**Re: Response to Preliminary Geologic/Seismic Hazard Review and
Supplemental Geologic Investigation
Proposed Senior Housing Facility
4200 Dove Hill Road
San Jose, California
Langan Project No.: 770619902**

This letter presents our response to review comments by the San Jose Department of Public Works (SJDPW) dated 25 September 2015 regarding our Geotechnical Investigation and Geologic Hazard Evaluation report dated 30 June 2015 for the proposed senior Housing Facility project at 4200 Dove Hill Road in San Jose, California. SJDPW had several comments (designated 1 through 13 in their review letter) regarding geologic/seismic hazards evaluation and mitigation at the site; a copy of the review letter is included in Appendix D. The project will consist of two new buildings, designated as Buildings A and B; both buildings are proposed to be four stories above a podium level as shown on Figure 1.

Drawing No.
C4.02
Sheet 6 of 12

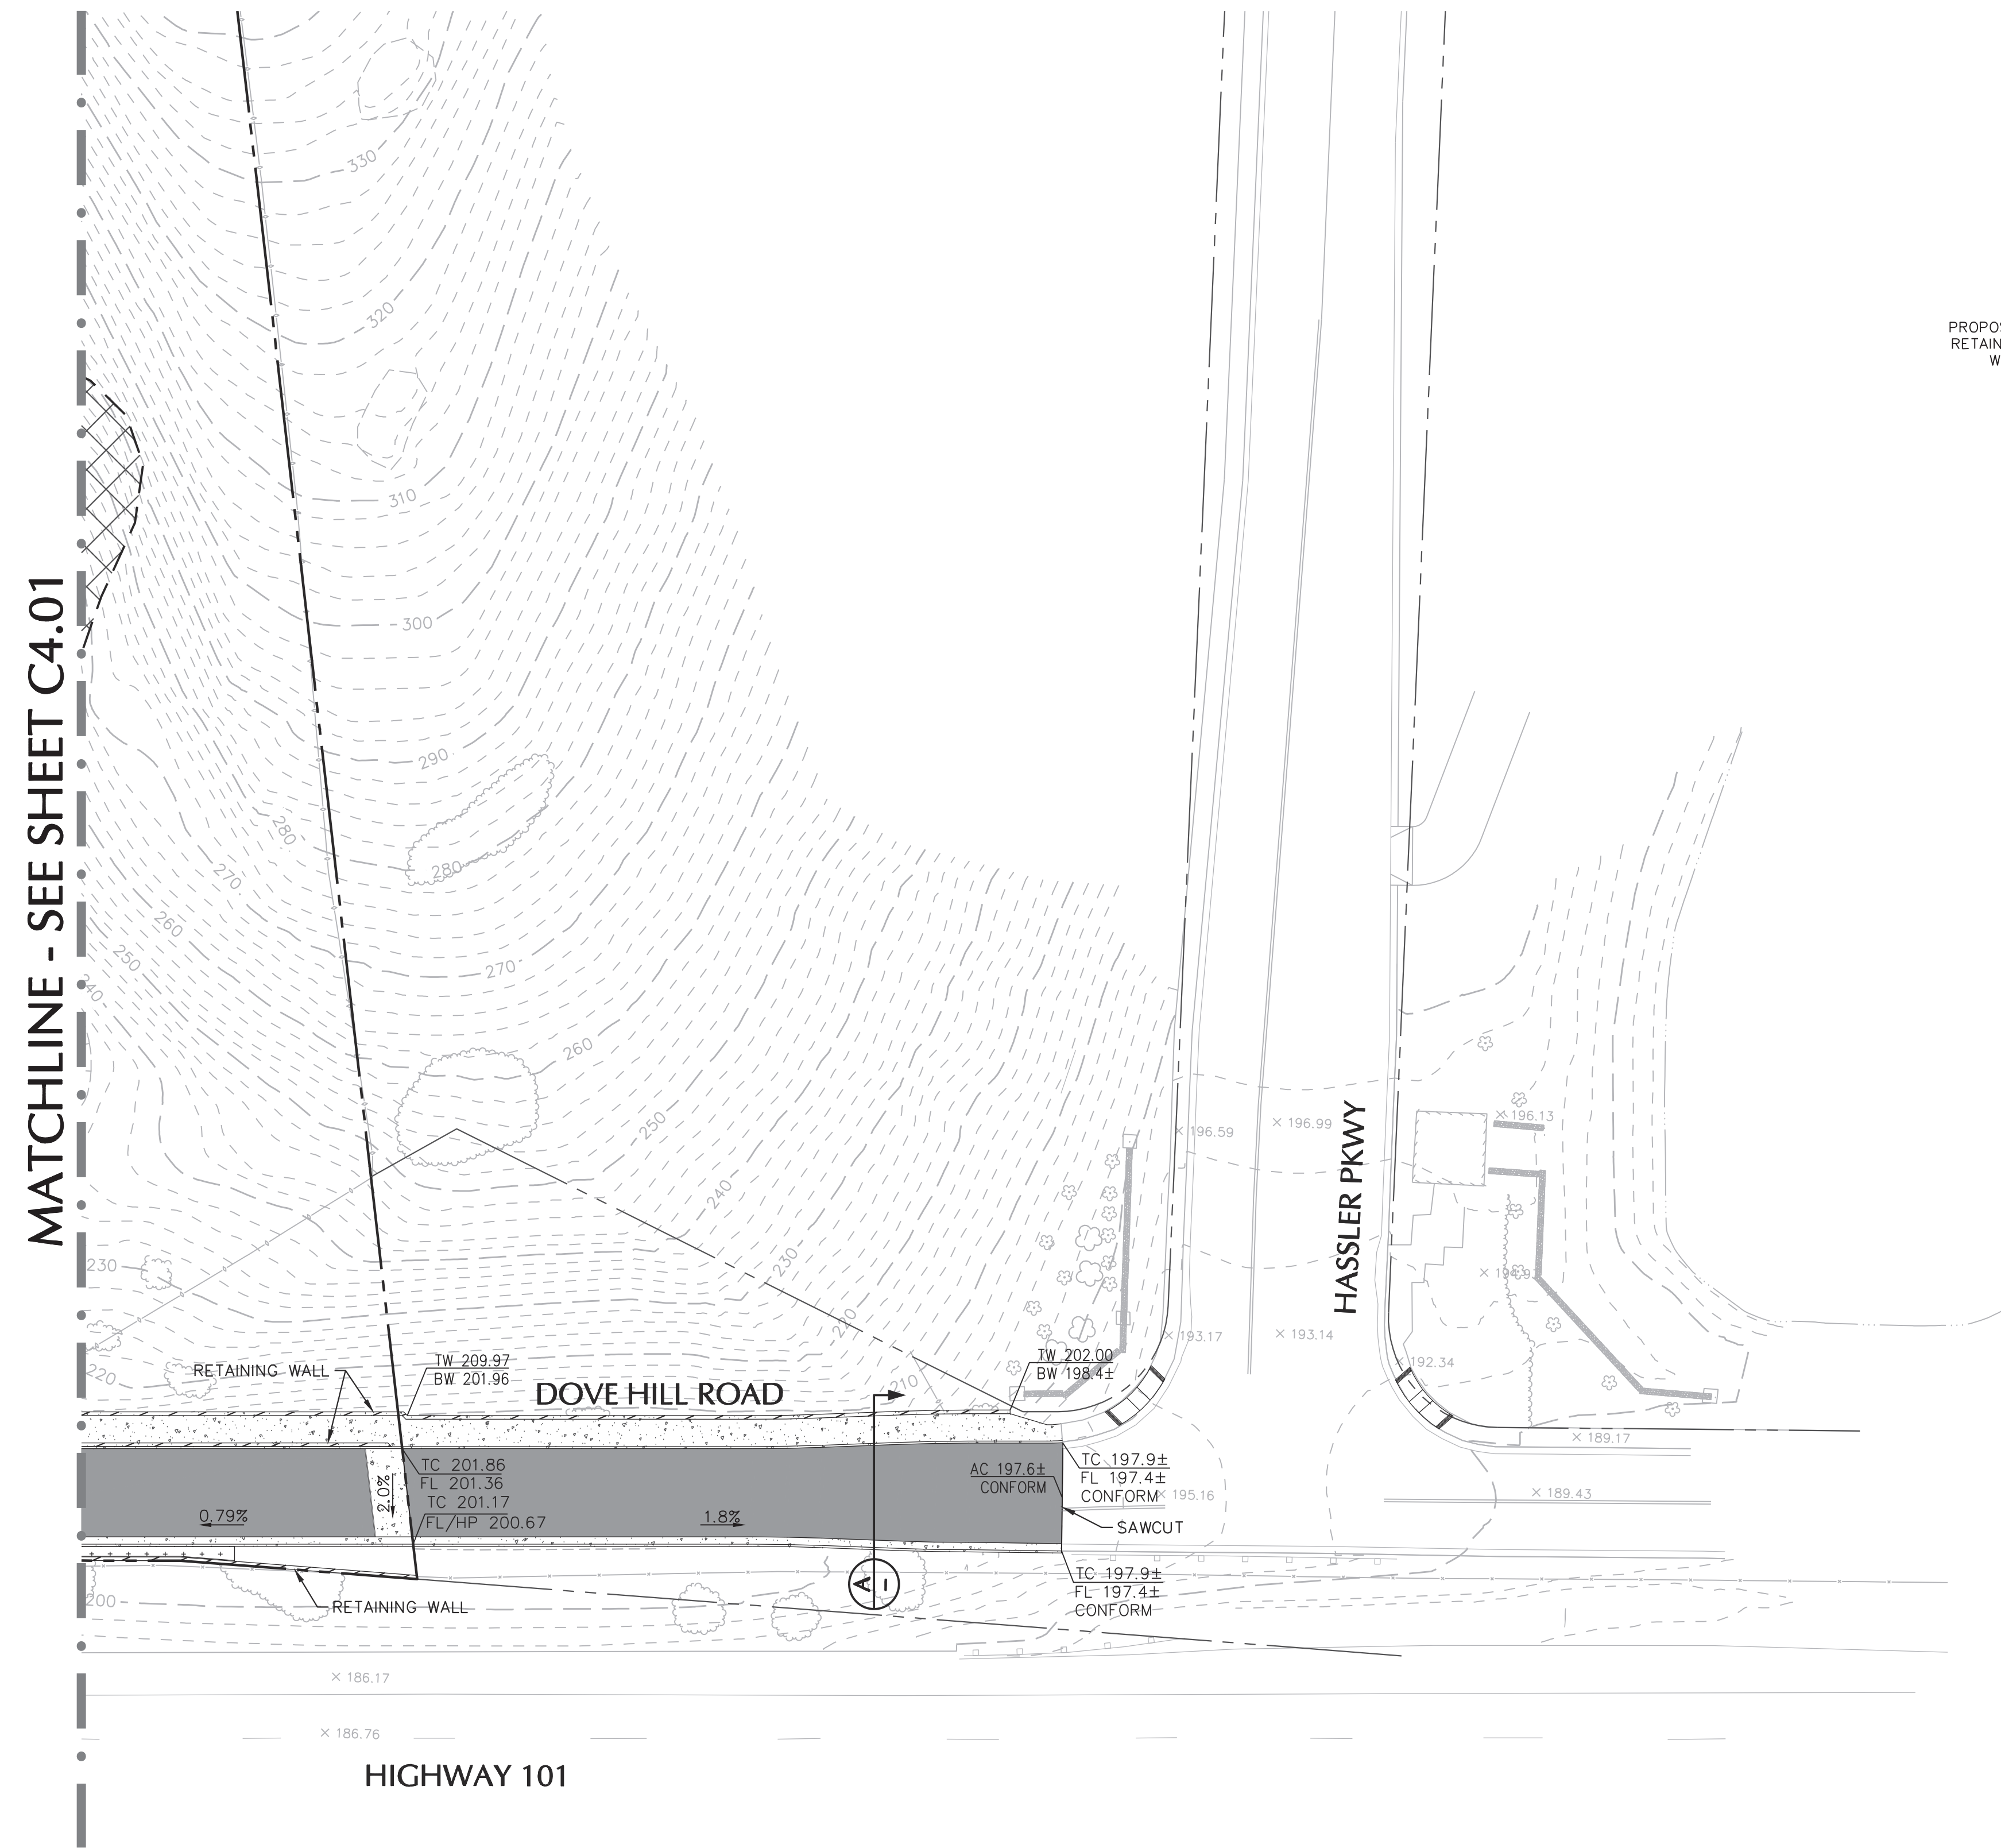
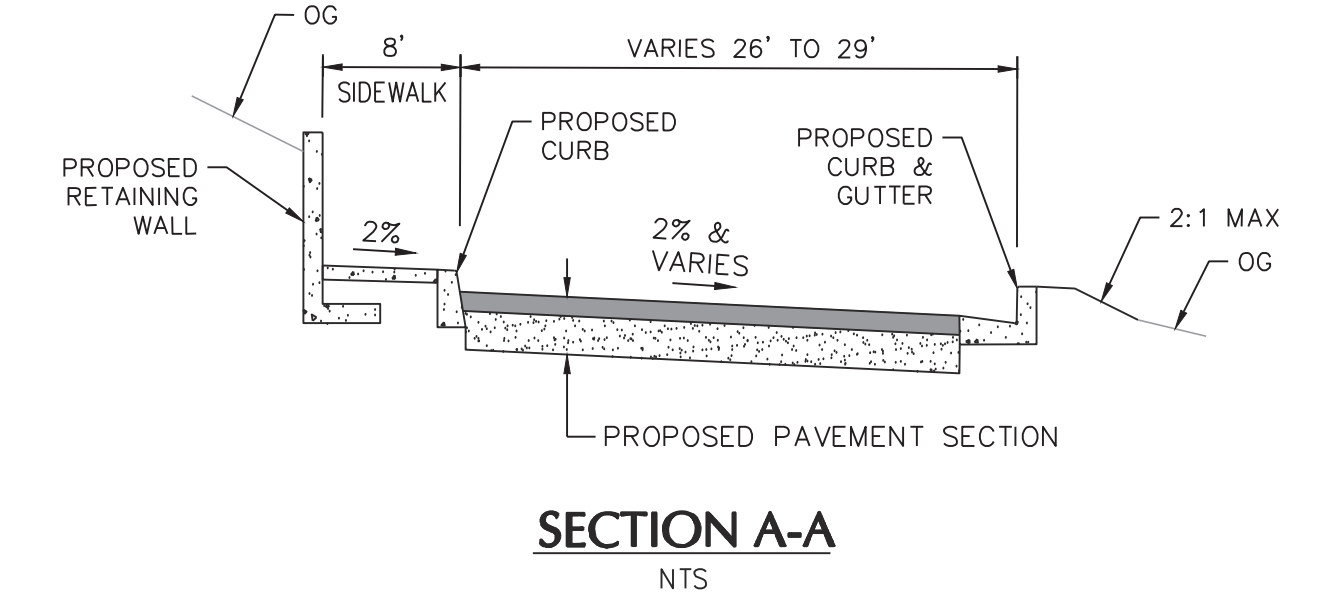
SJDPW stated that large cut and fill slopes are not shown on the grading plan and that the proposed grades do not appear to have been incorporated into our slope stability analysis models. They requested that proposed cut/fill slopes and finished grades be shown on the grading plan and incorporated into the slope stability analyses and analyzed for static and seismic slope stability.

SJDPW stated that the northeastern portions of Buildings A and B are immediately adjacent to high existing slopes and the buildings need to be setback at least 15 feet from the toes of these slopes to be in conformance with the City's Grading Code, Section 17.04.410. The purpose of the setback is to allow for positive surface drainage around the perimeter of the buildings and to establish a buffer zone to mitigate potential impacts from surface water runoff, erosion, and slope instability.

The grading plans have been modified with a 15 foot setback zone and are shown on the figures presented in Appendix C.
